Call for a review of the SMF optical powers

Piers Dawe

Introduction

Chart from
stassar_061417_3cd_adhoc-v2

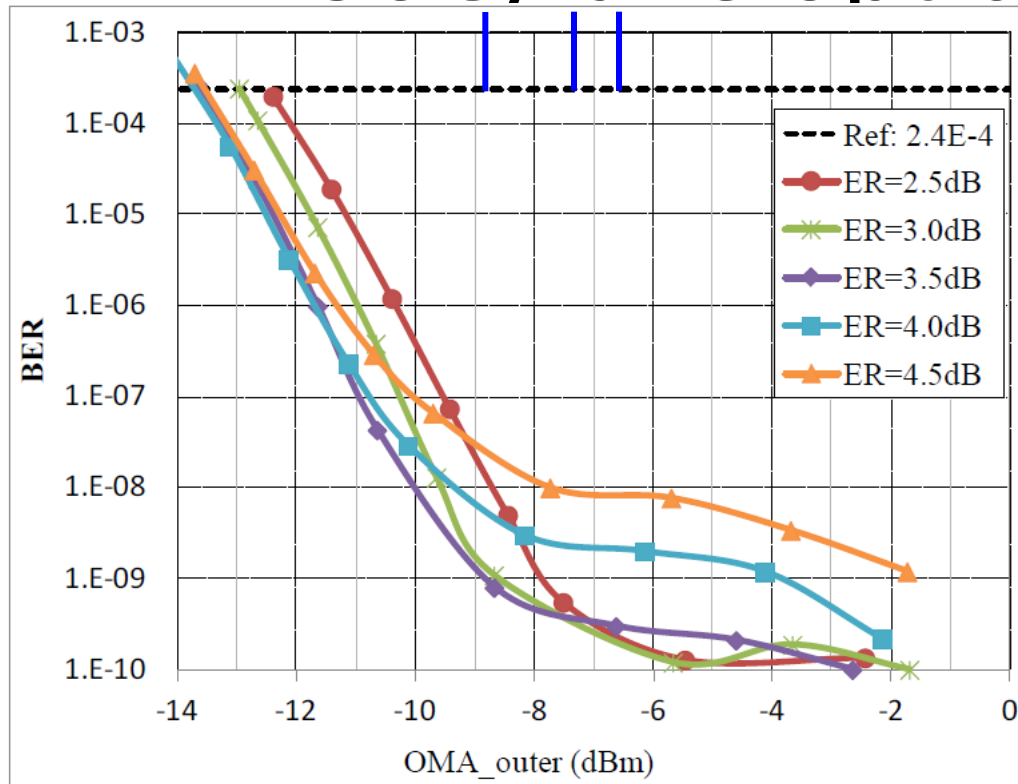
- Blue lines represent unstressed sensitivity (informative) for 50GBASE-LR (-8.8 dB), 50GBASE-FR (-7.3 dB) and 200GBASE-DR4 (-6.6 dB)
- There is possibly 4 dB margin for LR, 5½ dB for FR, 6 dB for DR4, plus the SECQ of this test transmitter
- This is much more encouraging than the early results with PAM4
 - Is this representative of performance during the life of the standard?

Is this the right amount of margin?

- From this margin, we need to allow for:
 - Manufacturing variation
 - Measurement inaccuracy
 - Temperature – see stassar_061417_3cd_adhoc-v2.pdf
 - Ageing
 - Possibly worse transmitters
 - For 200GBASE-FR4, 200GBASE-LR4, 400GBASE-FR8, and 400GBASE-LR8, WDM losses and sometimes little more MPI and chromatic dispersion
- However, the transmitter usually costs more
 - Particularly power consumption
- So we should set the optical power levels so as not to waste sensitivity

How much lower should the power levels be set?

Chart from
mazzini_051017_3cd_adhoc

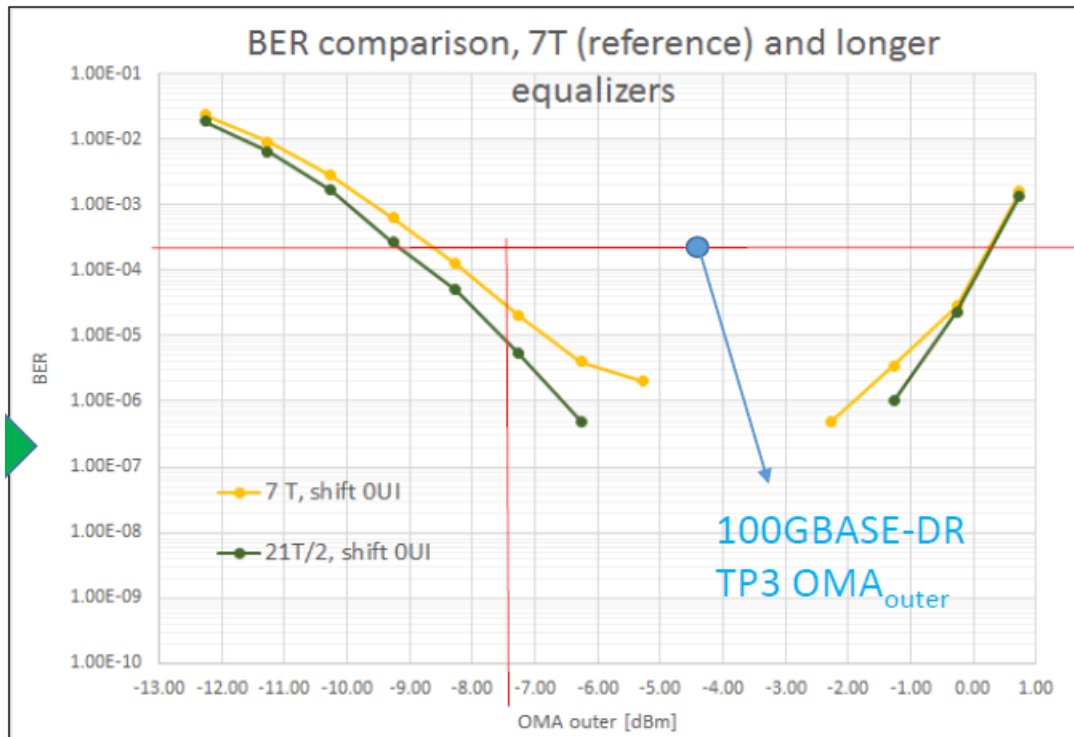
- Blue dot represents unstressed sensitivity (informative) for 100GBASE-DR and 400GBASE-DR4 (-4.4 dB)
- There is possibly 4 dB margin
- This is much more encouraging than the early results with PAM4
 - Is this representative of performance during the life of the standard?

How much lower should the power levels be set?
